Carnarvon fascine development

Shire of Carnarvon

Report and recommendations of the Environmental Protection Authority

Figure 2. Proposed concept plan for development of Carnarvon fascine area Source: Public Environmental Review 1992.

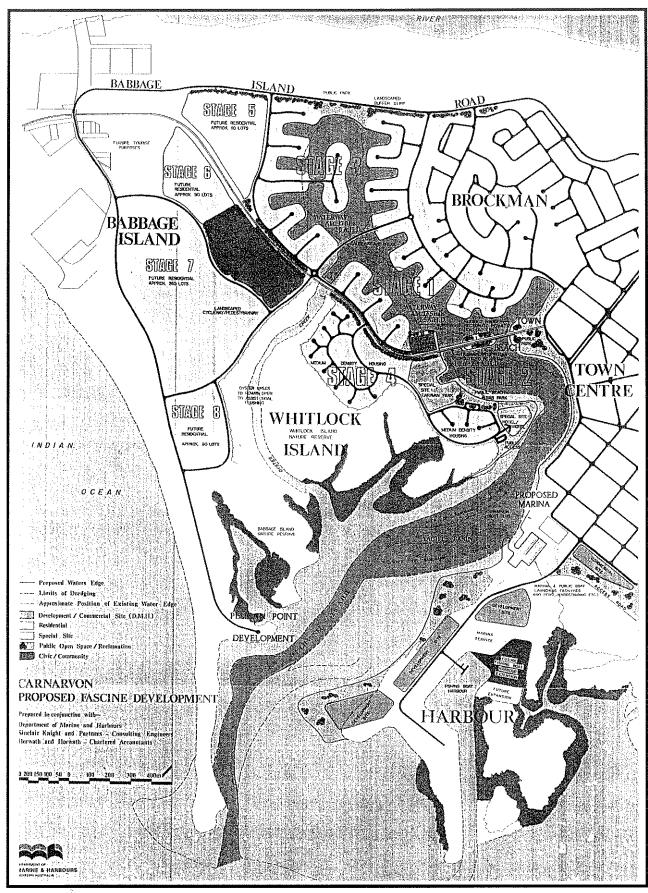
The Authority has concluded that urban development on Whitlock Island, as proposed within the southern portion of Stage 1 and 2, and all of Stage 4 is environmentally unacceptable due to the potential impact on the environmental value of the island. The Authority considers that the creation of urban residential subdivisions at the proposed locations may lead to significant direct and indirect environmental impacts on the islands, which would be extremely difficult to control and manage.

The Environmental Protection Authority recommends that urban and canal development proposed on Whitlock Island, as indicated within the southern portion of Stages 1 and 2, and all of Stage 4 is environmentally unacceptable.
